Transport Assessment

State Significant Development Application – Modification 3

657-769 Mamre Road, Kemps Creek (SSD-9522) Modification 3

TABLE 2 RESPONSE TO TFNSW COMMENTS – EMAIL OF 3 NOVEMBER 2021

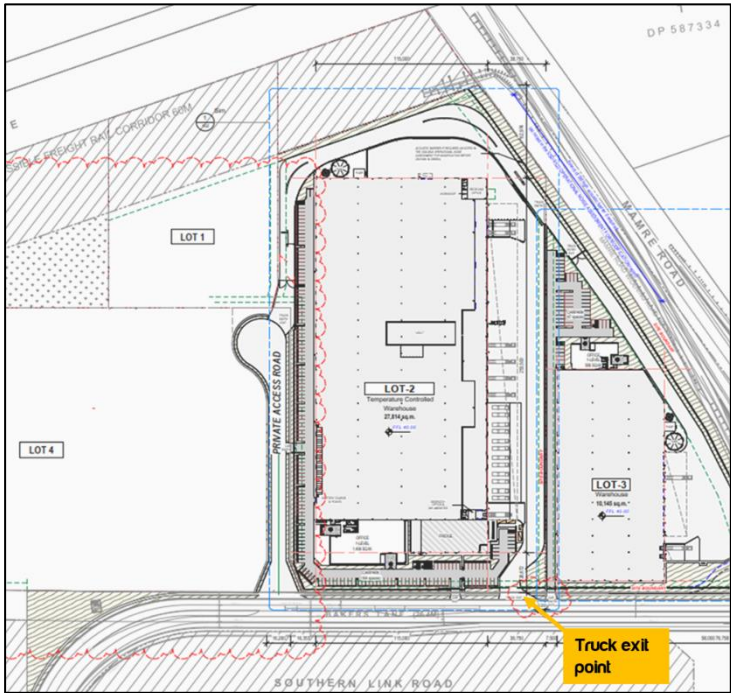
No.	Comment	Ason Response
SLR Layout (CO13362.01-SK30-A)		
1	A modelling memo needs to be provided with the signal design to understand what steered the design.	Excluded from this application and will be referred to in a future MOD, as instructed by JV. This MOD 3 will not seek approval for the signal and Lots 1 and 4 anymore.
Proposed interim design – IF2-KC-FS-550-B		
2	Unclear of the distance from the signals to the access closest to Mamre Road – clarification required.	Excluded from this application.
3	Access closest to Mamre Road – in order for a 26m B-double to undertake the turn they would need to undertake the turn from the wrong side. Any access should be able to accommodate for simultaneous entry/exit.	<p>It is noted that the heavy vehicle access point shown in the following figure is the closest to Mamre Road.</p>  <p>It is important to note that this access point is a heavy vehicle exit point only for Lot 2 (which does NOT ACCOMMODATE ENTRY movements). Therefore, 26.0m B-double trucks will not undertake entry movements for Lot 2 (from this access crossover).</p>

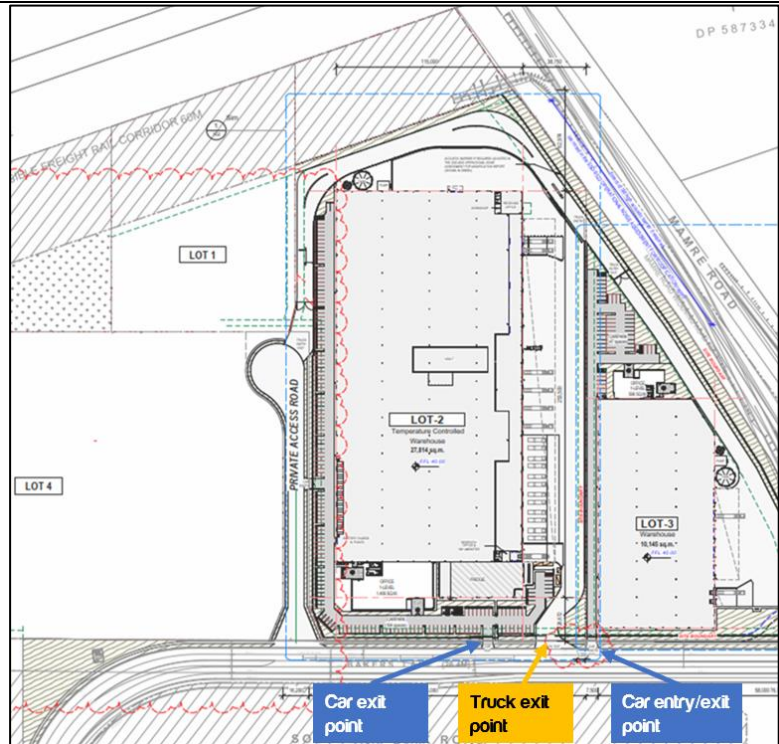
4	3 driveways shown in close proximity (closest to Mamre Road) – light access, heavy access and light access – concern with conflicting movements, swept paths missing.	The three closest access points to Mamre Road are shown in the figure below.

With regards to the western light vehicle access point and the heavy vehicle access point, they will be restricted to exit only. Therefore, light vehicles and heavy vehicles will not undertake turns from the wrong side of Bakers Lane to enter the respective Lots.

With regards to the light vehicle access point (within close proximity of Mamre Road for Lot 3), its distance from the Bakers Lane / Mamre Road intersection is ~180m and generates limited traffic primarily associate with staff movements. Hence it is unlikely to have any material impact to the proposed Mamre Road / Bakers Lane signal.
